Planning and Development Committee Meeting

02 December 2015

Local Planning Scheme No. 1
Application: Industry Extractive - P2150048
Schedule of Submissions for 105 Bon Accord Road (Lot 110) King River

Yakamia/Lange Structure Plan

Advertised Plan

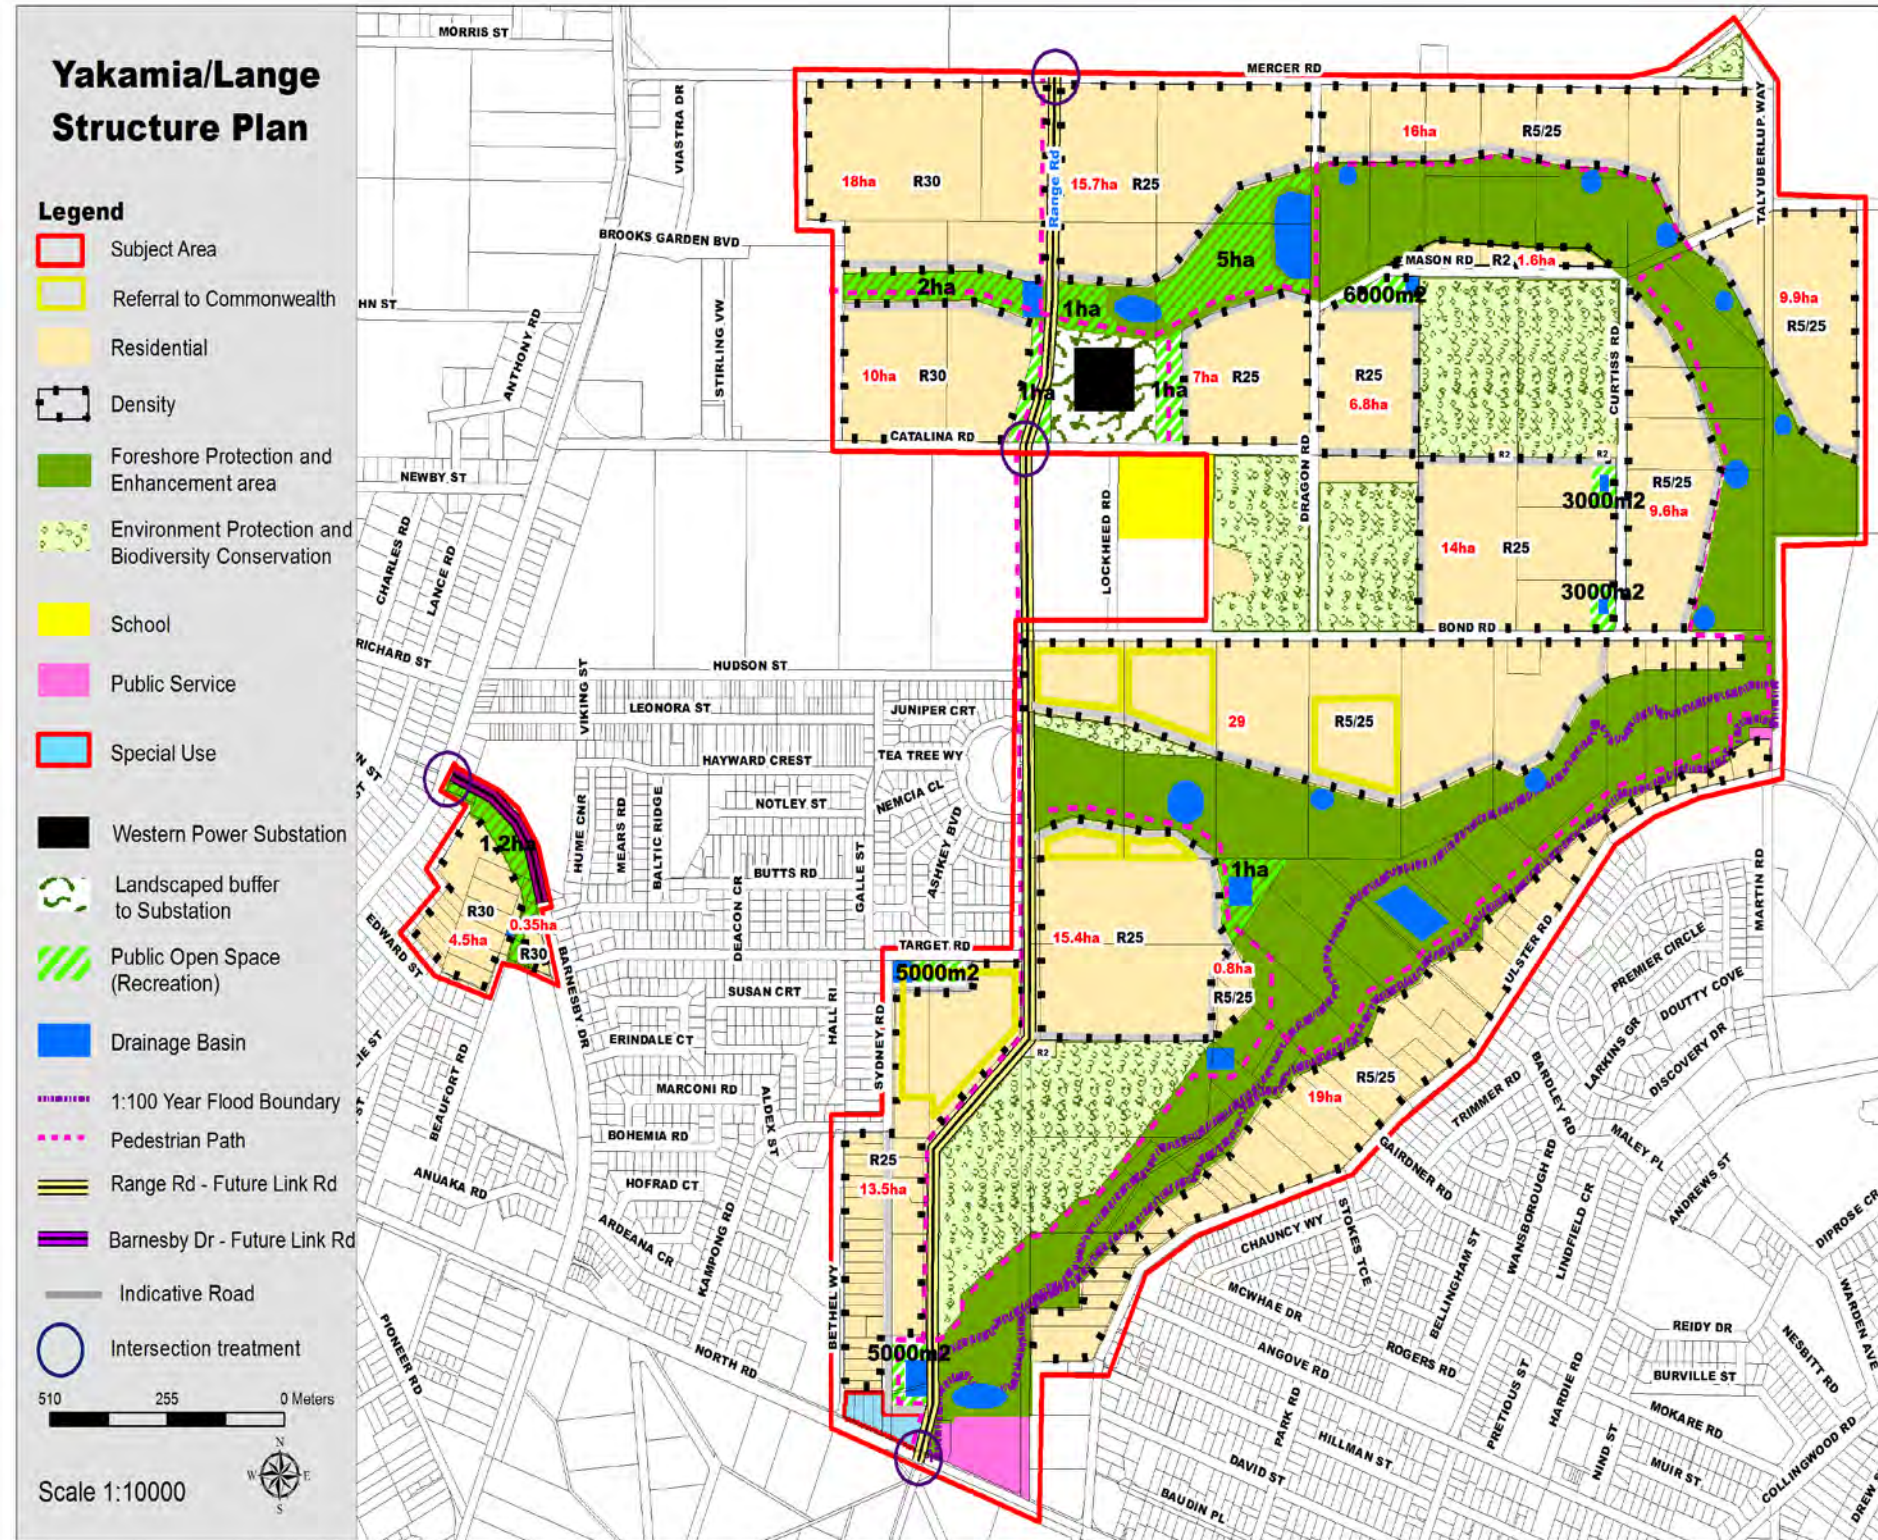
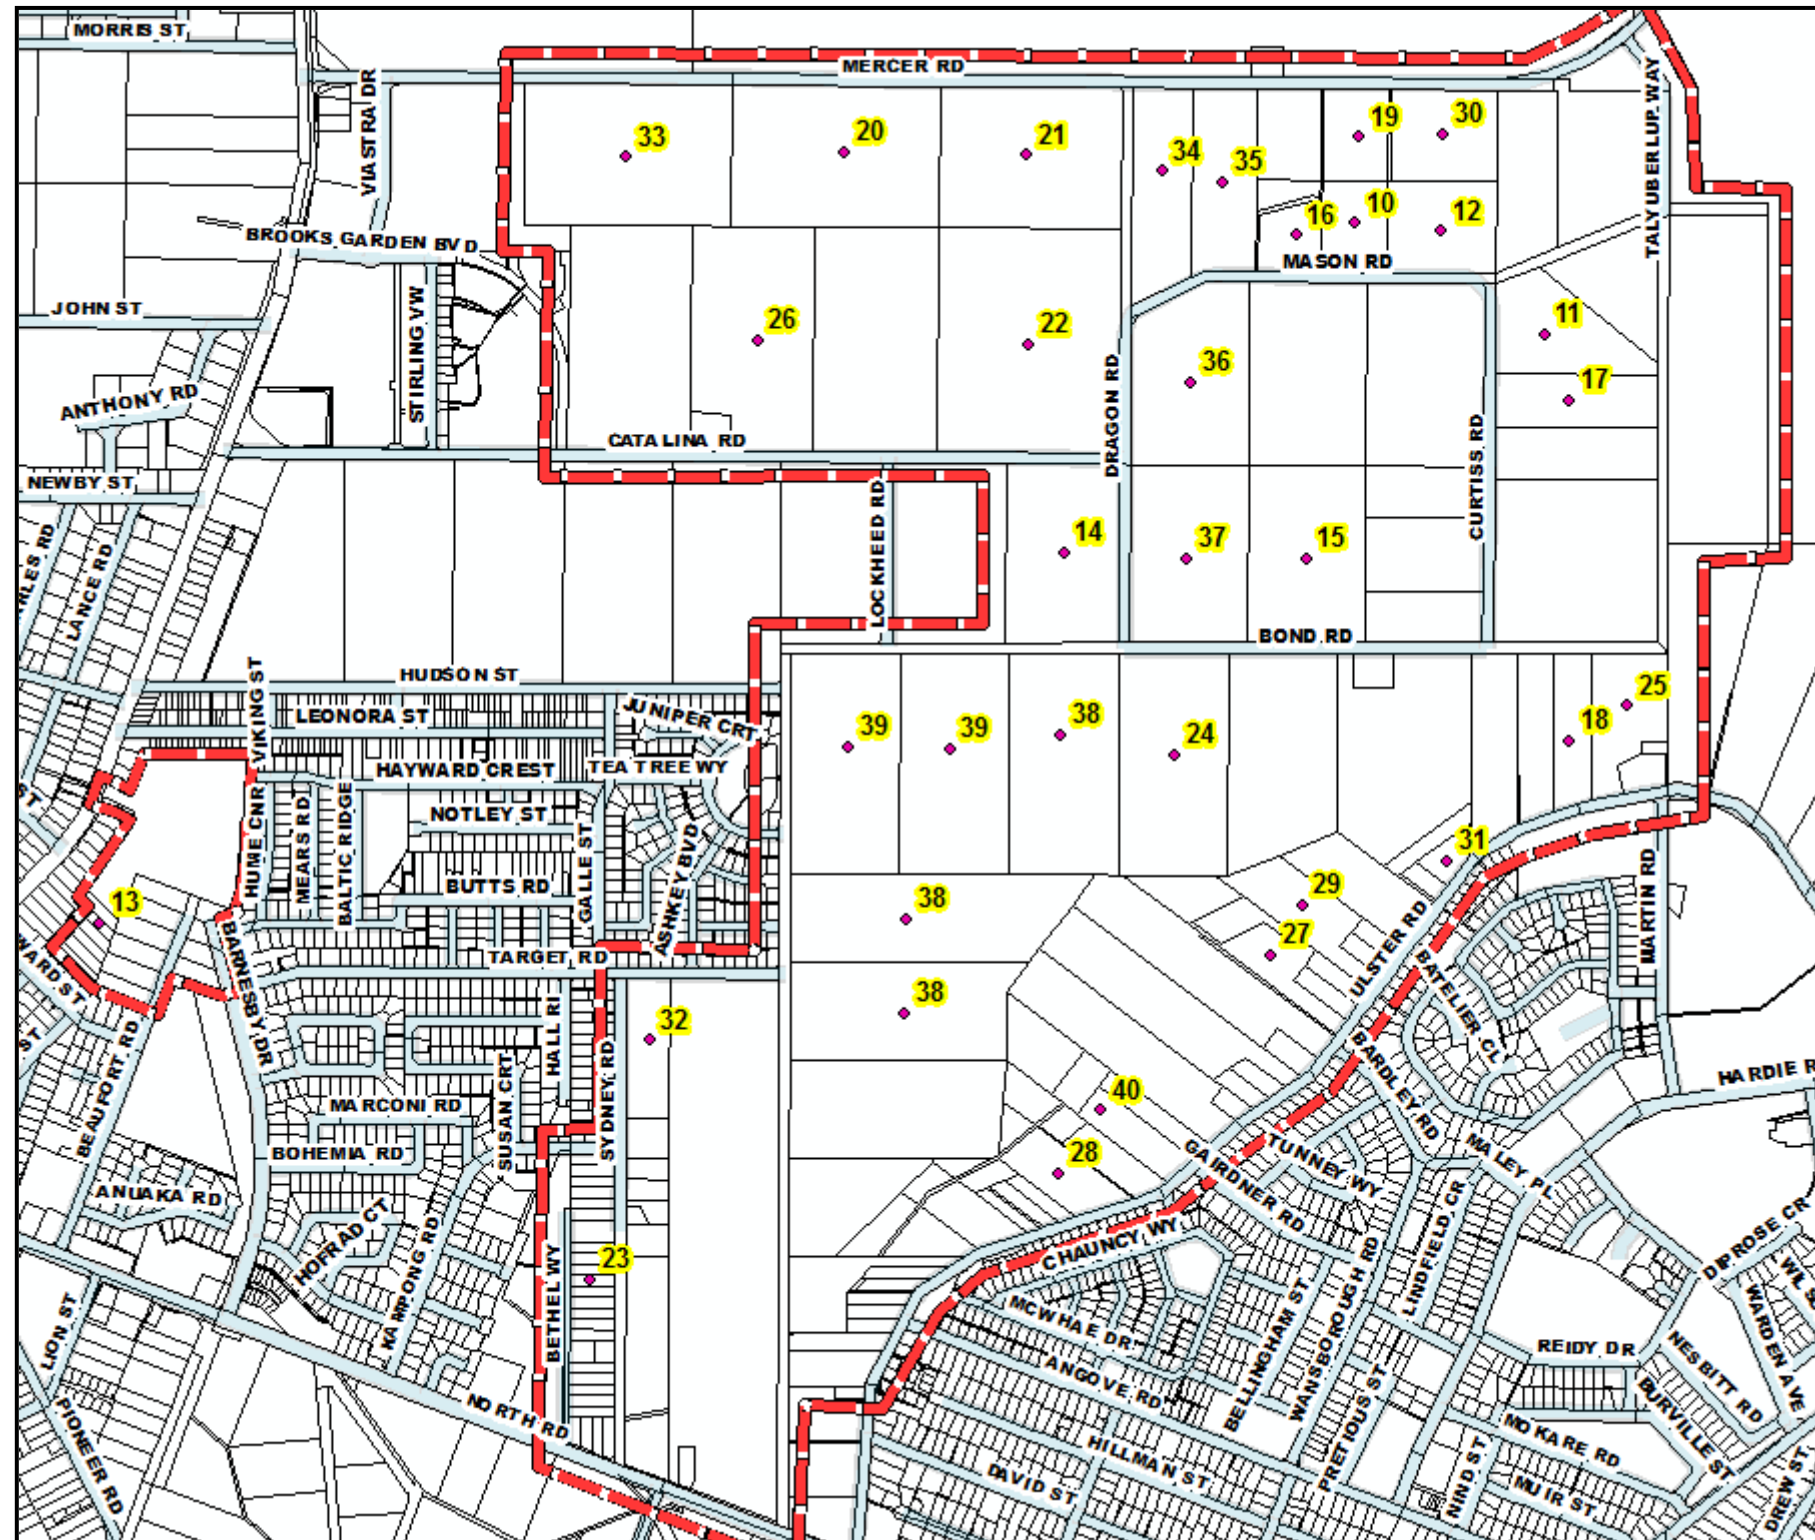
No	Submission	Comment - Landholder	Recommendation - COA
1	Main Roads Western Australia	<p>Barnesby Drive to Chester Pass Road Intersection</p> <p>1. The proposed connectivity via Barnesby Drive to Chester Pass Road would increase conflict points on Chester Pass Road and would have a substantial impact on properties adjacent to this intersection.</p> <p>Main Roads considers the connection of Barnesby Drive to Hudson Street and the connection Hudson Street to Catalina Road as a solution in providing connectivity. This would negate the need for the Barnesby Drive/Chester Pass Road intersection.</p> <p>Contributions</p> <p>1. Amend point 'g)', page 57 of the draft structure plan.</p>	<p>Barnesby Drive to Chester Pass Road</p> <p>1. The City requested MRWA to consider a left in and out connection between Chester Pass Road and Barnesby Drive.</p> <p>Main Roads agreed that this may work subject to a dedicated left turn pocket into the proposed Barnesby Drive intersection and an acceleration lane from the intersection onto Chester Pass Road, heading toward the roundabout.</p> <p>Recommend that the structure plan is changed such that connection to Barnesby Drive is restricted to left out and left in only.</p> <p>Contributions</p> <p>1. Delete point 'g)', page 57 of the draft structure plan, which reads:</p> <p><i>The Barnesby/Chester Pass Road intersection (approximate value - \$1.5million) is to be funded by Main Roads WA and the City of Albany.</i></p>

Figure 12 - City of Albany (2013), Yakamia Structure Plan Area, Environmental Assessment (Aurora Environmental).

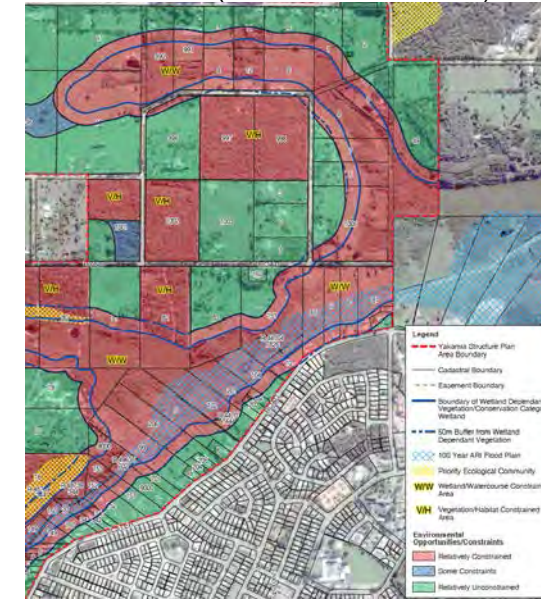
1. The extent of the foreshore buffer area to the creek came about from the following environmental study, which identifies a standard setback distance to watercourses: City of Albany (2013), Yakamia Structure Plan Area, Environmental Assessment (Aurora Environmental).

Standard setback distances to watercourses, as indicated by the draft structure plan may not be true to land characteristics (e.g. topography (steep/flat), height above sea level, historical events, flow velocity of water, width of creek, evidence of erosion and wetland dependent vegetation).

City of Albany (2013), Yakamia Creek Arterial Drainage Plan – 1 in 100 year event.

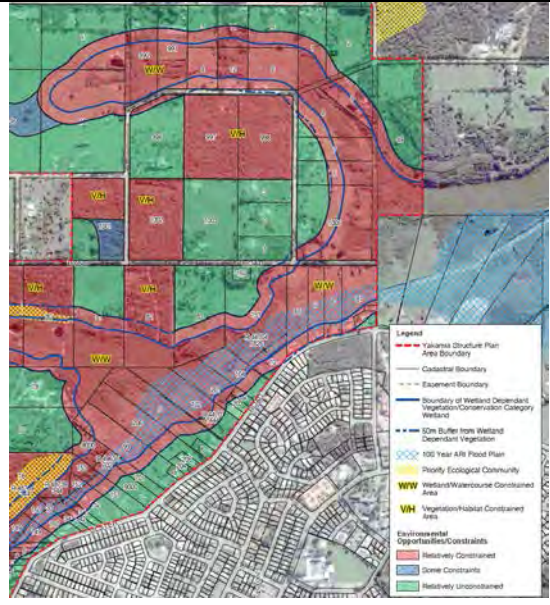
The City of Albany (2013), Yakamia Creek, Arterial Drainage Plan (Essential Environmental) identifies areas within the Yakamia catchment as being susceptible to various elements including flooding or erosion. For Lot 12 Mason Rd, the arterial drainage plan concludes the potential for erosion during a 5yr event and flood risk during a 1 in 100 year flood.
